PROJECT ADDRESS:

1523 W. 7th St.
Santa Ana, CA 92703

ADDITIONAL STRUCTURAL CALCULATIONS

**RESIDENTIAL PLAN CHECK
 COMMENTS**

FLOOR FRAMING PLAN

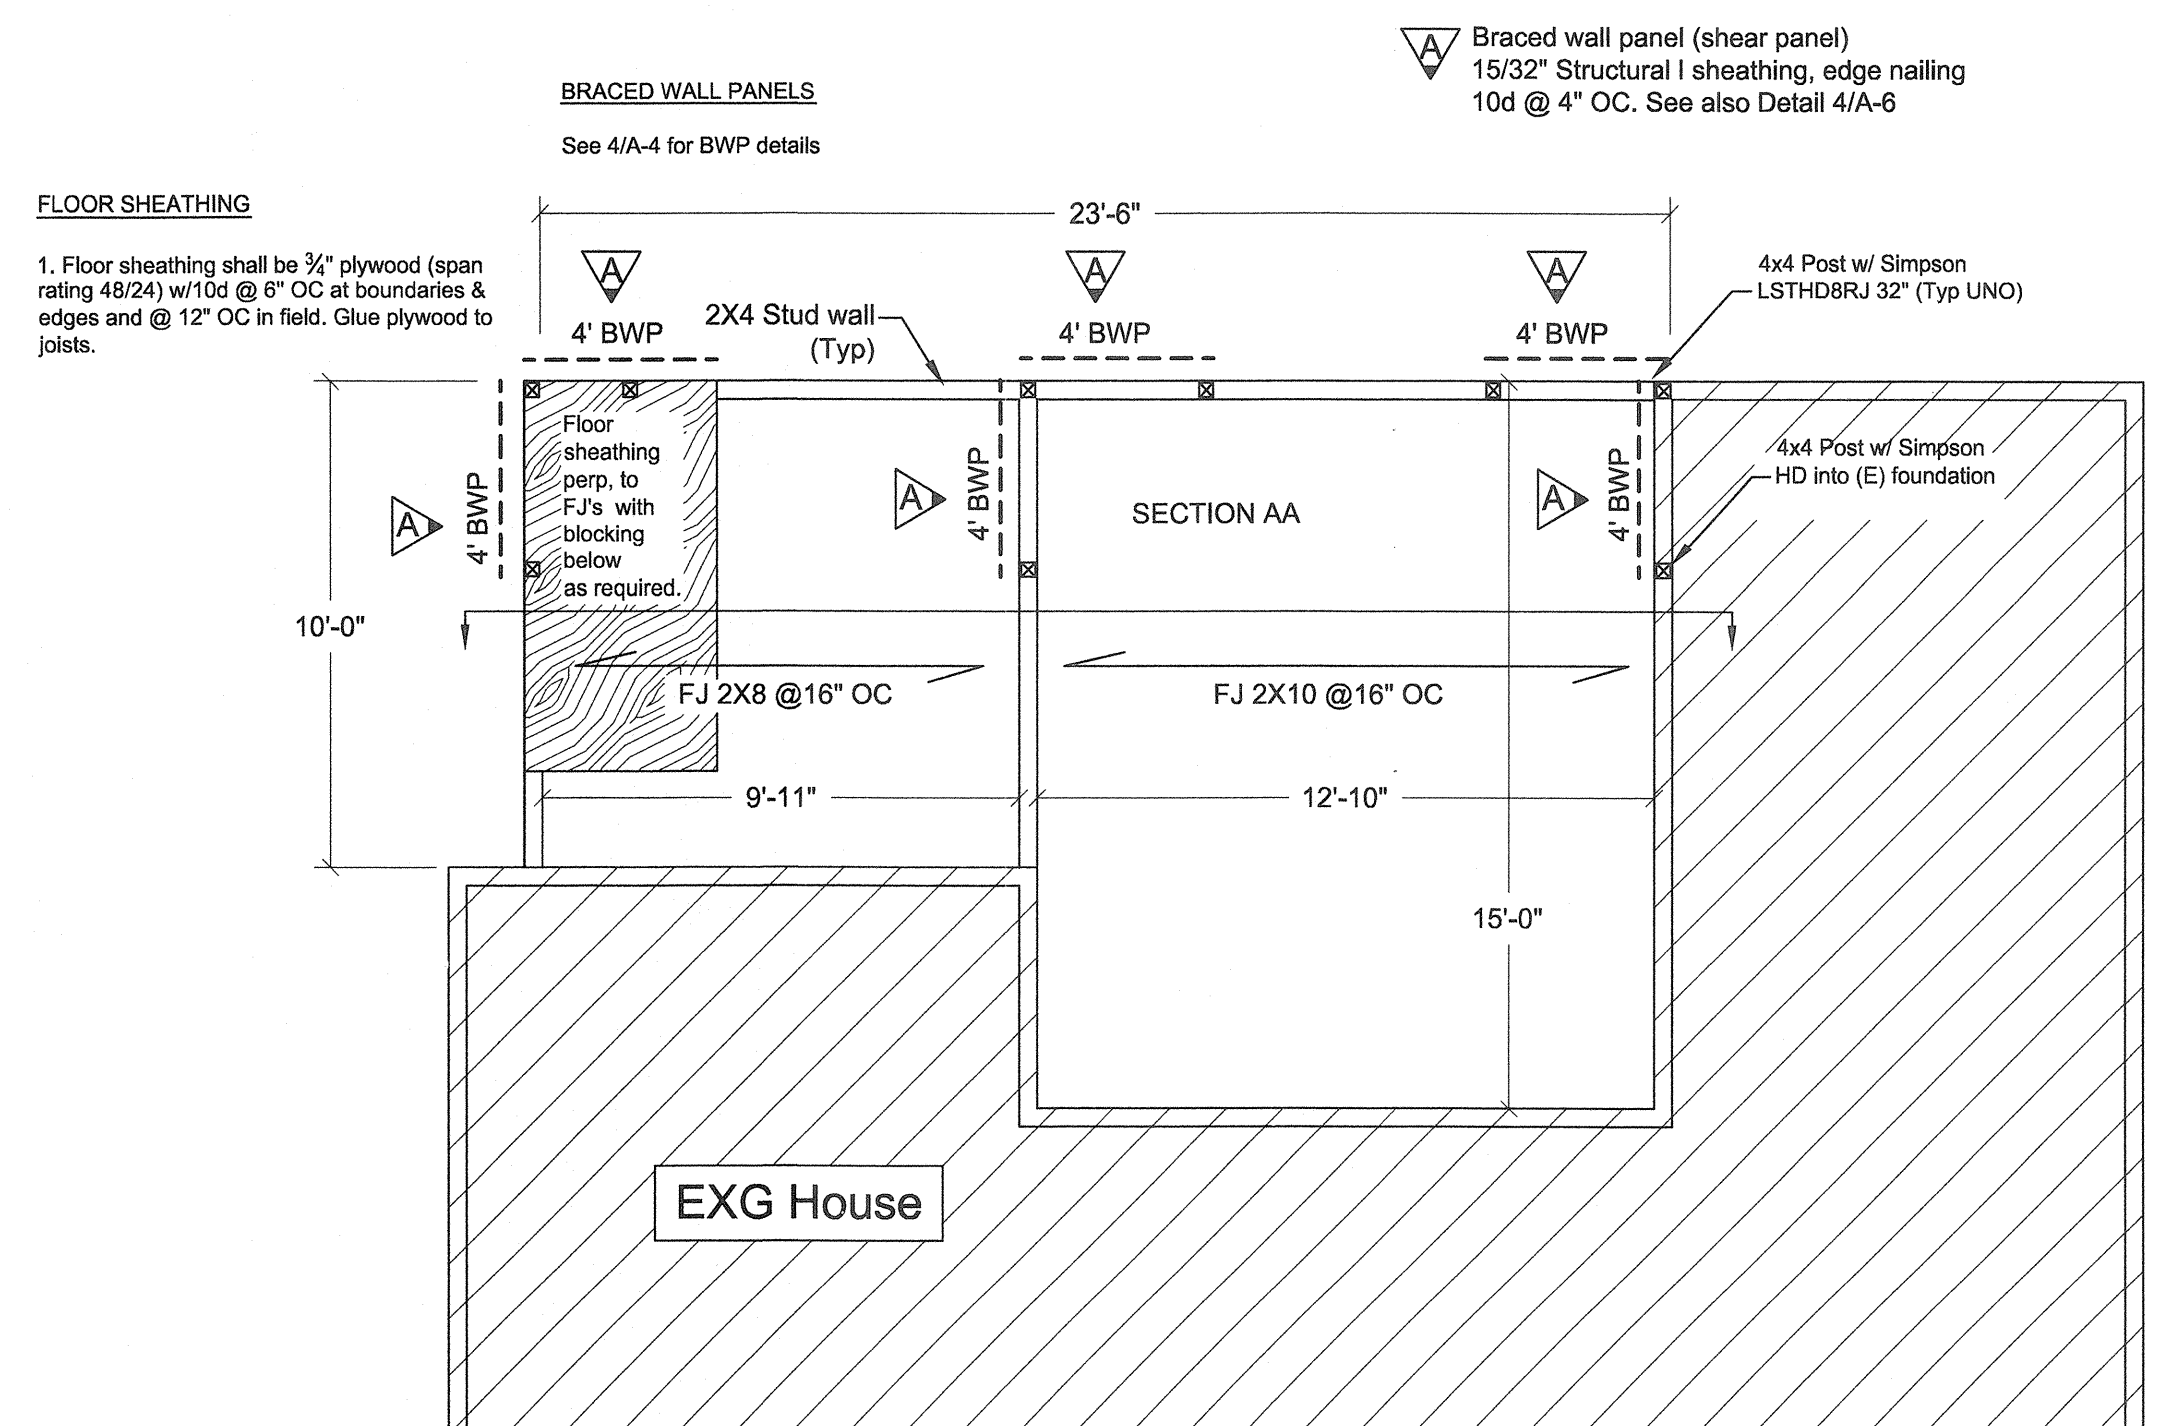
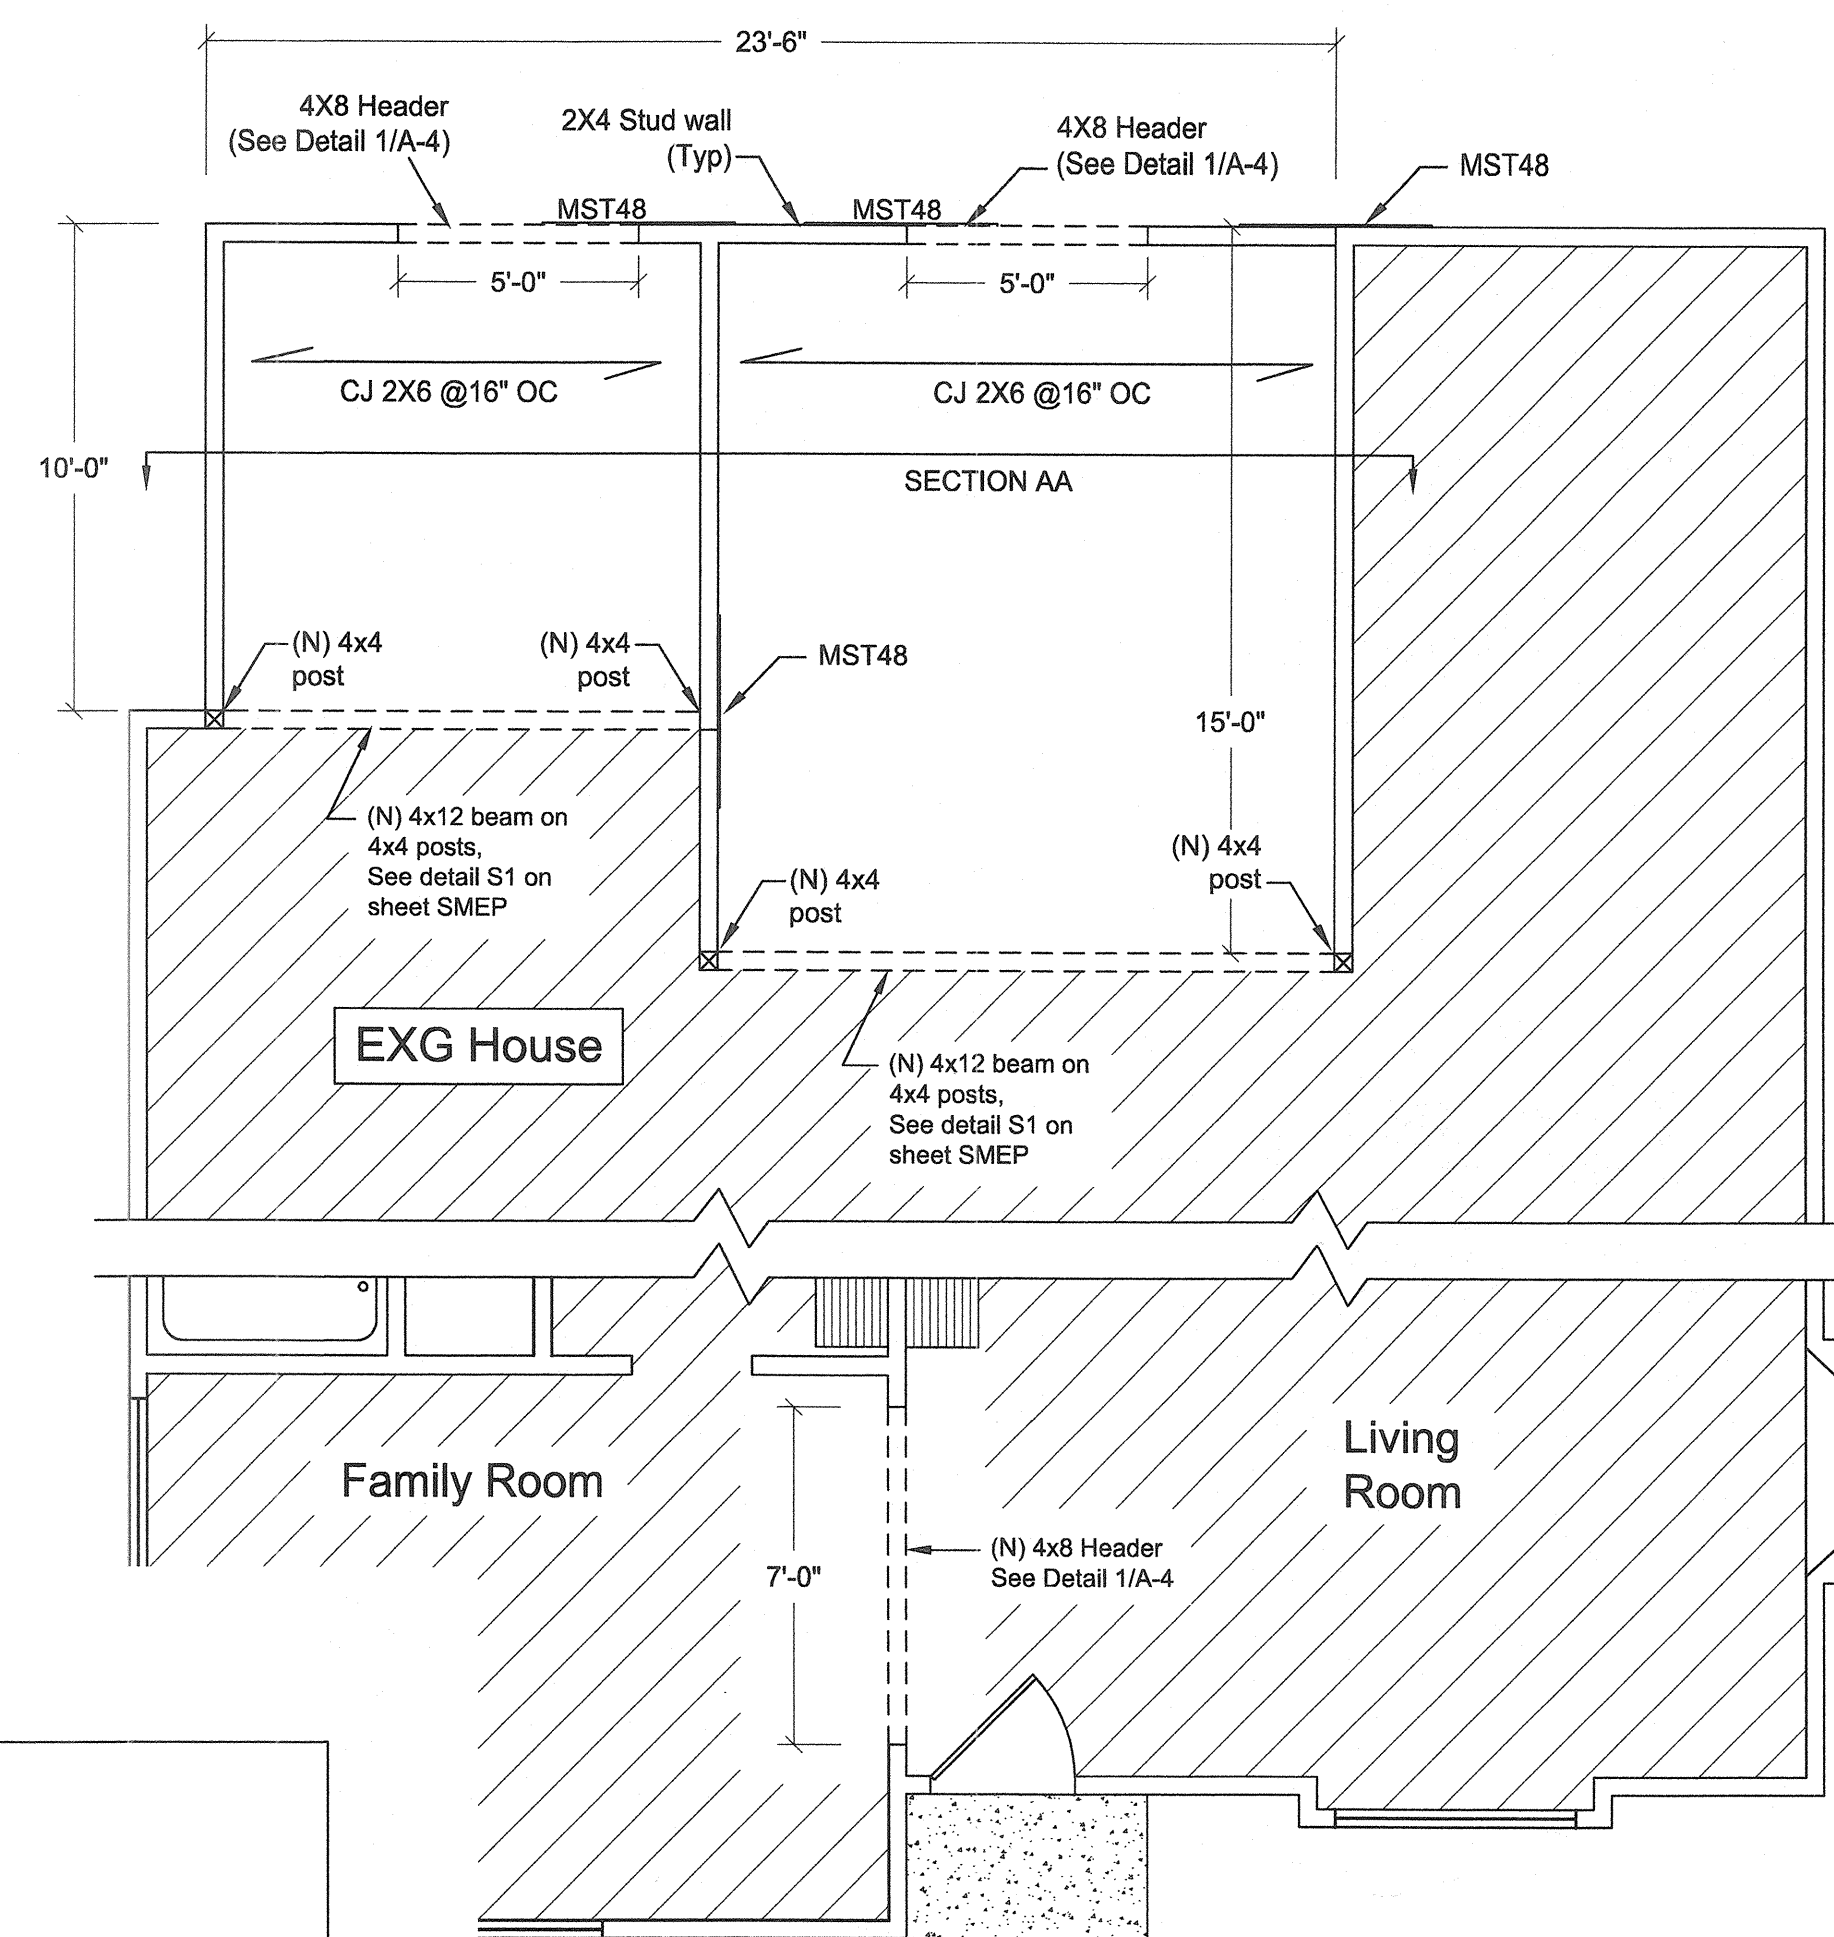
20. Show all the headers and beams on the framing plan. SHEET A4

21. On the drawings, provide Nailing Schedule in conformance with CRC Table R602.3(1). A-4

22. Provide shear wall at all sides of the addition. SHEET A4

33. Openings greater than 4 feet in dimension must be detailed with doublers, blocking and straps or provide engineering. SHEET A-4
